**AGENDA**  
**City of Dallas Planning**  
**Commission**  
**TUESDAY, October 11, 2022 - 7:00 p.m.**  
**City Hall Council Chambers**  
**187 SE Court Street**

**CITY OF DALLAS  
PLANNING COMMISSION  
STAFF REPORT**

**Application Type:** Detailed Development Plan & Preliminary Subdivision  
**Owner / Applicant:** Meadows Investment, LLC  
**Location:** Barberry Mixed Use Master Plan Node

EXHIBIT B

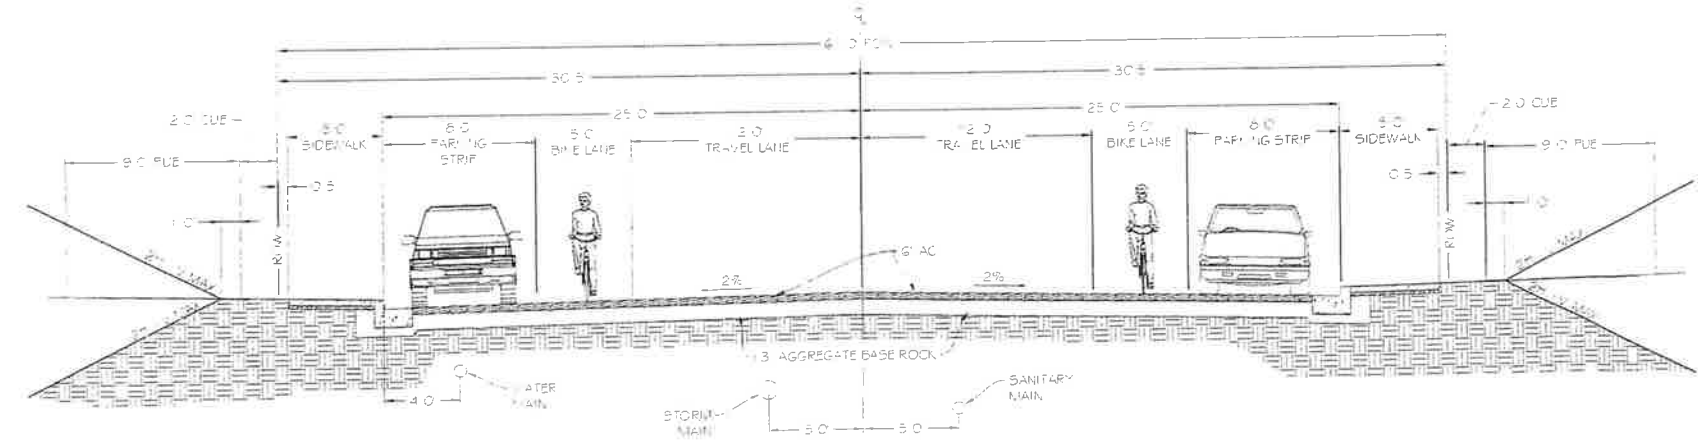
The previously approved modified design of Barberry Avenue, approved in 2017 in file #MOD-17-04, was explicitly requested and approved only for that portion of Barberry Avenue between Academy Street and Hankel Street (terminating on the south side of Hankel Street). Staff are generally supportive of the extension north of Hankel of the multi-use path in-lieu of the northbound bike lane, but have concerns about the possible need for turn lanes in the high-density residential and commercial areas, which the applicant states a willingness to accommodate, but does not specify where such lanes would be provided.

The previously approved modified design of Hankel Street, approved in 2020 in file #MOD-18-01, was approved only on the site of the former drive-in theater. This approval was specifically because the modification of the master plan to develop the drive-in theater for residential use made apparent the need for a through street, but the authority of the City to require a standard width collector at a location not depicted on the Dallas Transportation System Plan was ambiguous, an ambiguity that does not exist elsewhere on Hankel.

- g. The construction plans shall illustrate collector street cross-sections as depicted in Applicant's Exhibit D. *Applicant's proposed condition. This is consistent with prior approvals, so staff do not object provided the commission finds the criteria of DDC.4.5.040 satisfied.*

EXHIBIT Y

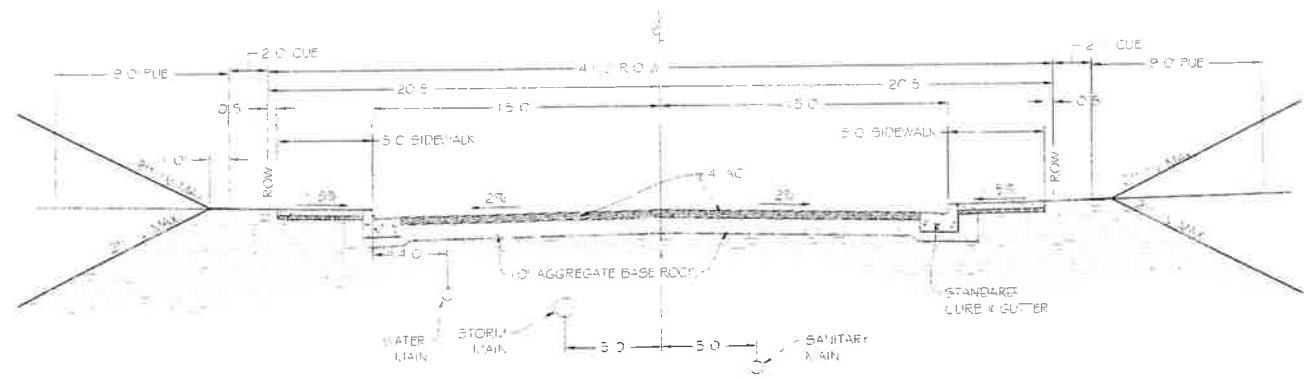
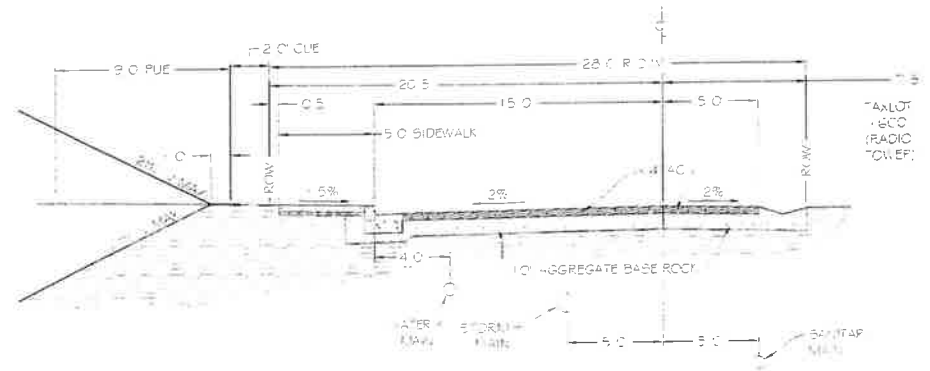
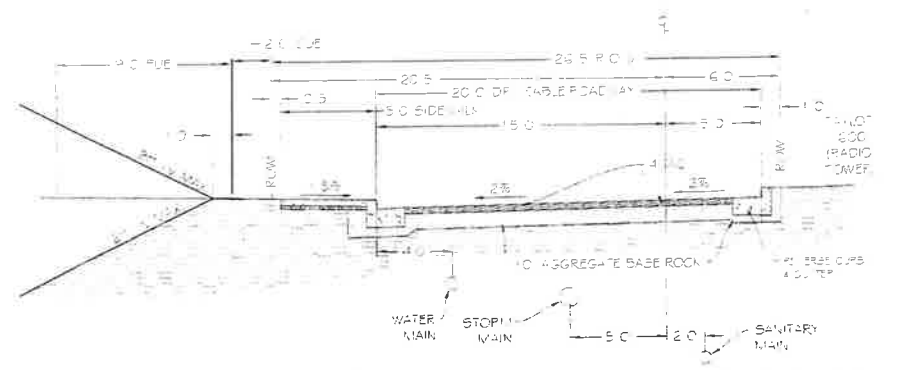
- e) The construction plans shall show the full length of SE Boysenberry Avenue to have a ~~curb~~ to-curb-curb-to-curb paved width of ~~320~~ feet, with a 5 foot sidewalk ~~and landscape strip~~ on the south side, and no-parking allowed on either side of the street, being located within a 26.5-foot-wide right-of-way, as per Applicant's Detail 2B on Exhibit Y, for the portion of Boysenberry Avenue that adjoins the radio station property. The remaining portion of Boysenberry Avenue shall be constructed as per the street cross-section of Detail 1 of the Applicant's Exhibit Y.

Planning staff do not support the proposed half-street abutting the radio tower property, designated SE Boysenberry Avenue in applicant's plans. There is nothing in Code allowing half-street development, and where exceptions have been allowed in the past it was abutting sites with near-term development potential; in this case, there is nothing in the record to indicate that the radio tower property will be redeveloped anytime in the foreseeable future. Therefore, if the development is approved by the Planning Commission, a recommended condition of approval should require this section to be constructed as a local street with 30 feet curb-to-curb, and 5 foot sidewalk and landscape strip on the south side. The additional 4,000 square feet of pavement this requires, which would be presumed to accommodate an additional 28 on-street parking spaces, can be found to be roughly proportionate to the impact of 173 new dwellings, being 23 square feet of pavement per dwelling.

- e. The construction plans shall show the full length of SE Boysenberry Avenue to have a curb-to-curb paved width of 20 feet, with a 5 foot sidewalk on the south side, and no parking allowed on either side of the street, being located within a 26.5-foot-wide right-of-way, as per Applicant's Detail 2B on Exhibit Y, for the portion of Boysenberry Avenue that adjoins the radio station property. The remaining portion of Boysenberry Avenue shall be constructed as per the street cross-section of Detail 1 of Applicant's Exhibit Y. *Applicant's proposed condition. Meets fire code minimums but not dev. code street standard; street standards may be modified provided the commission finds the criteria of DDC.4.5.040 satisfied.*

- f. The construction plans shall illustrate local street cross-sections as depicted in Applicant's Exhibit Y. *Applicant's proposed condition. This is consistent with prior approvals, so staff do not object provided the commission finds the criteria of DDC.4.5.040 satisfied.*
